Re: Offer of Partial Settlement; Turners Falls Hydroelectric Project (FERC No. 1889-081) and Northfield Mountain Pumped Storage Project (FERC No. 2485-063)

**COMMENTS OF THE CONNECTICUT RIVER CONSERVANCY
IN OPPOSITION TO OFFER OF SETTLEMENT**

Figure 1. Relicensing Study 3.3.1, Figure 5.3.2-1

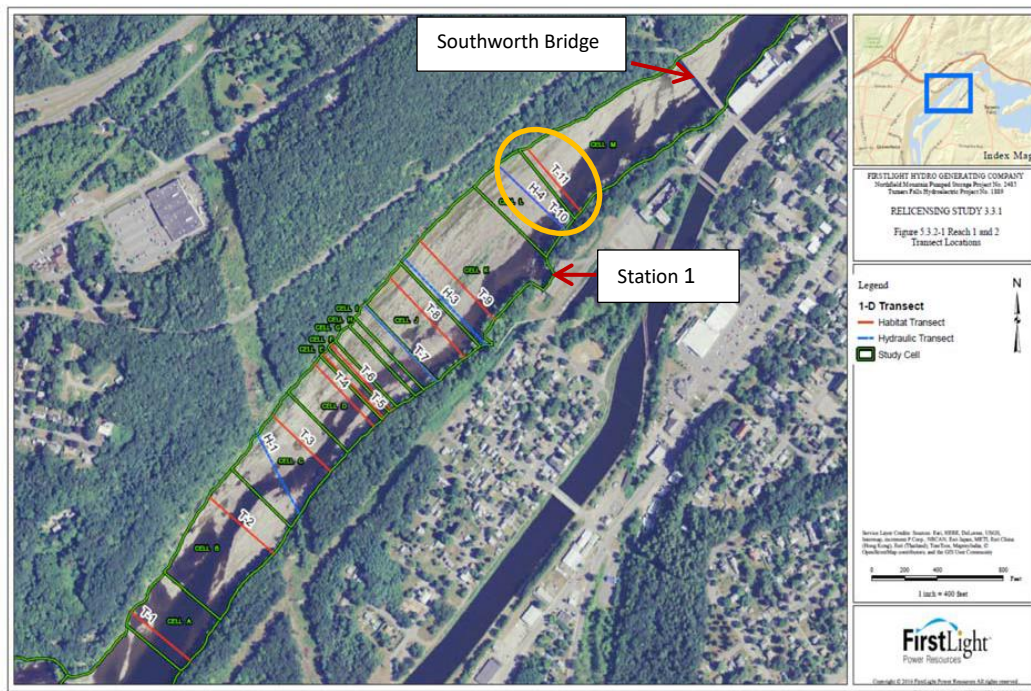
10. Study 3.3.1 analyzed transects 10 and 11 for habitat (WUA) in Reach 1 of the “bypass channel” below the immediate area of the dam. Figure 1, below, shows the area of the transect analysis.

Figure 2. CRC letter dated June 13, 2022 to Secretary Bethany Card, Massachusetts Executive Office of Energy and Environmental Affairs.

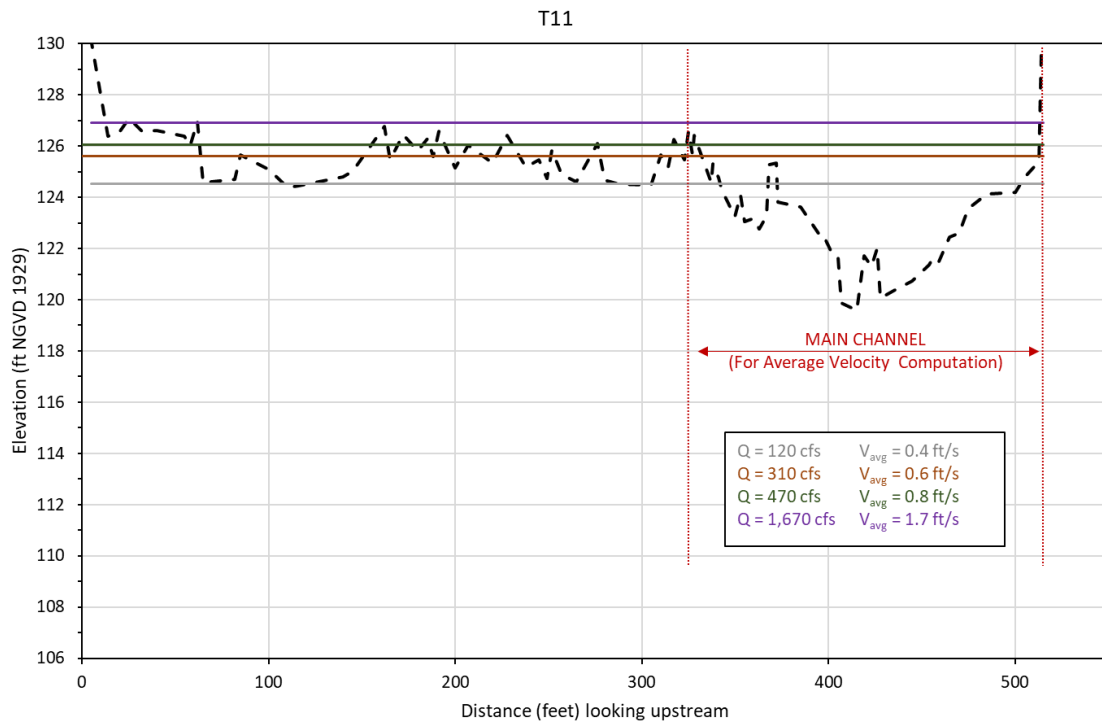
7. Macroinvertebrate habitat at 500 cfs is only 10% of the maximum available. As shown in Figure 2 below, at 500 cfs much of the river would not provide the flow (velocity and/or

15. Water levels at Transect 11 are shown for four flows in Figure 2 below. At 470 cfs (green line) approximately 35% of the transect is either dry or minimally wetted. At 1,670 cfs (purple line) the full river width is wetted increasing habitat for juvenile fish and macroinvertebrates. Based on the slope of the vertical right bank and near vertical left bank, a flow of 1,400 cfs would closely resemble that of 1,670 cfs (purple line).²

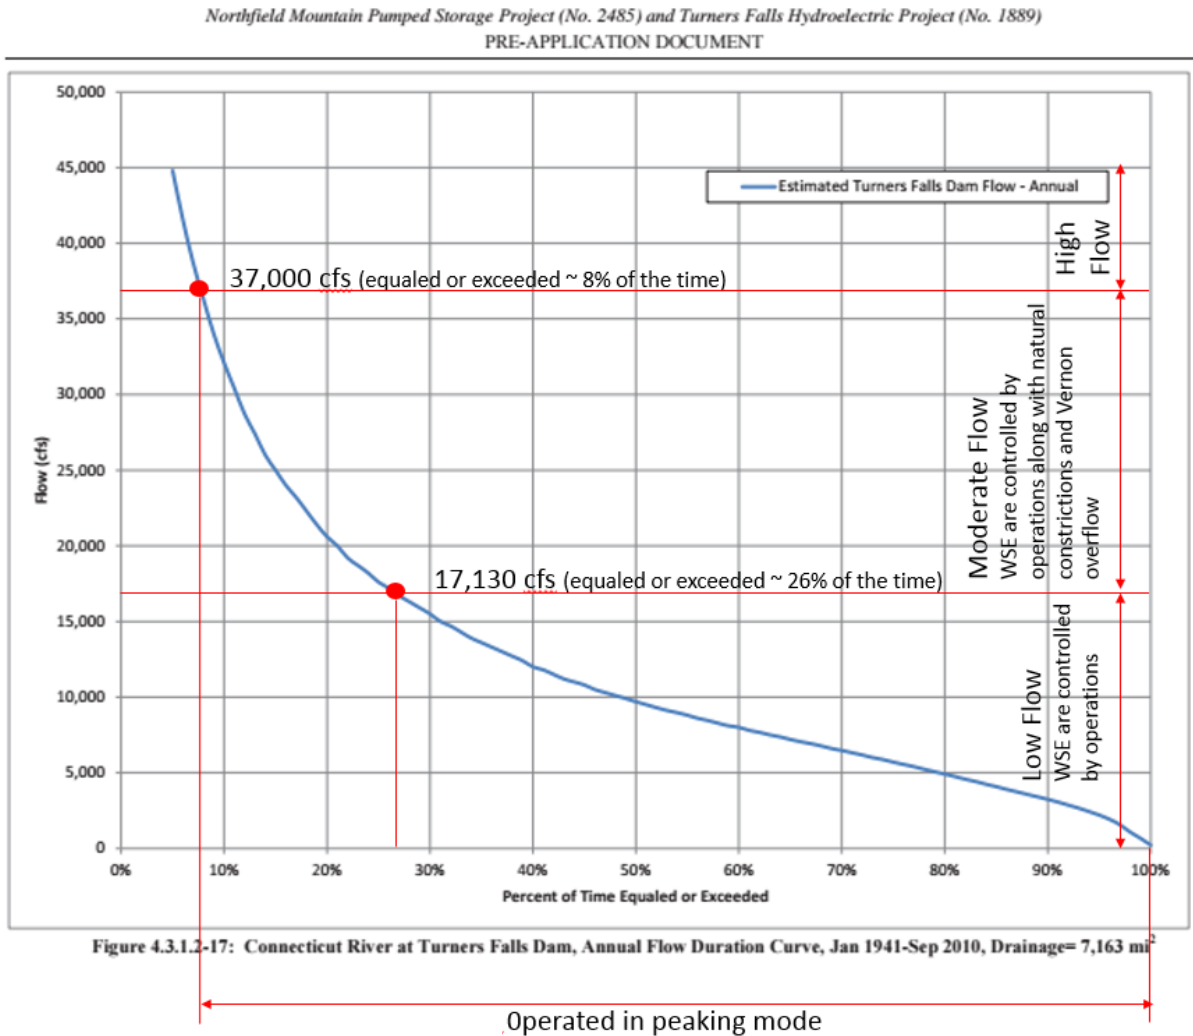
We do not agree with the determination that operations only impact the reach in which they have been allotted to in the Relicensing Study 3.1.2 (i.e. TF to Reach 1, NFM to Reach 2, and Vernon to Reach 4). The Energy Grade Line (EGL) approach described appears to only apply when looking at impacts associated with high flow (>37,000) where the 1-dimensional velocity and shear stresses determined through HEC-RAS play a dominant role in erosion. The report is clear that for flows below 37,000 cfs (moderate and low flows as per their definition), which occur over 90% of the time according to Figure 4.3.1.2-17 from the October 30, 2012, PRE-APPLICATION DOCUMENT (see figure that follows), the hydroelectric operations of Turners Falls and Northfield Mountain are both controlling factors for the WSE elevation fluctuation throughout the entire TFI, and that for flows below 17,130 cfs, Turners Falls, Northfield Mountain, and Vernon operations are the dominant influence controlling WSE fluctuation throughout the entire TFI. The analysis should not be limited based on hydraulic reaches that only seem applicable for high flows when over 90% of the time the flows in the TFI are lower than the defined high flow, and almost all of the WSE fluctuation caused by the combined hydropower operations is happening below the defined high flow, which is only equaled or exceeded less than 10% of the time.

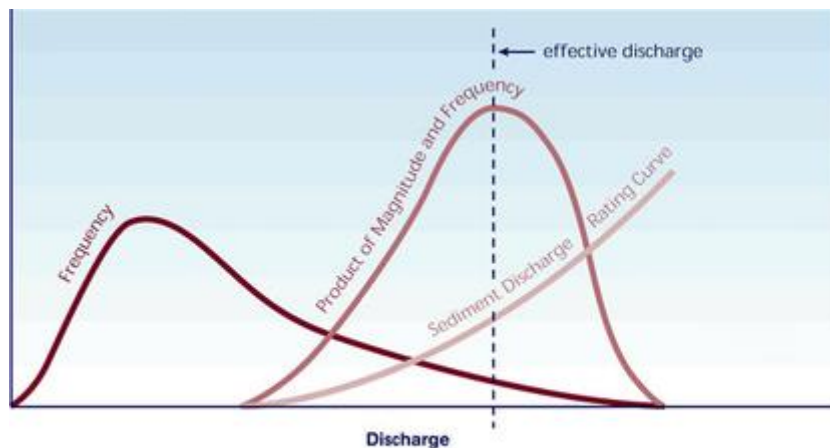
While the RSP stated that both primary and secondary causes of erosion would be assessed, it did not give a definition of those terms. The Relicensing Study 3.1.2 now renames these causes to dominant primary, contributing primary and secondary causes (page 621-622 of Vol II). It then arbitrarily defines the dominant primary as “one that is responsible for 50% (or >50%) of the erosion at a cross-section” and the contributing primary as being responsible for between 50% and 5% of the erosion at a cross-section. This was not described in the Revised Study Plan, nor was it agreed to by the stakeholders. These definitions are arbitrary in nature, lead to dismissing lesser but still important causes, and disregard multiple site specific impact results that come very close to the 5% limit that are associated with operational WSE fluctuations. Once a cause has been dismissed as not being a “dominant primary cause” it is then interpreted as 0% in the subsequent steps of the assessment. This is just one example where the Relicensing Study 3.1.2 uses arbitrarily assigned thresholds, not included in the Revised Study Plan, that potentially introduce bias to the results and limit what is truly being assessed (other examples include the flow thresholds, and the delineation of hydraulic reaches). Later in the Relicensing Study 3.1.2 (as shown on page 38 Vol 1) the document classifies the sites having “measurable/significant rates of bank erosion” by stating “[I]n order to be classified as having measurable/significant rates of bank erosion, the rate of erosion at a given site must be greater than the erosion rate that represents the lowest 5% of all rates or 0.163 ft³/ft/yr.” Again the threshold

applied seems arbitrary and in this case includes restored sites with little erosion post stabilization of the toe of bank.
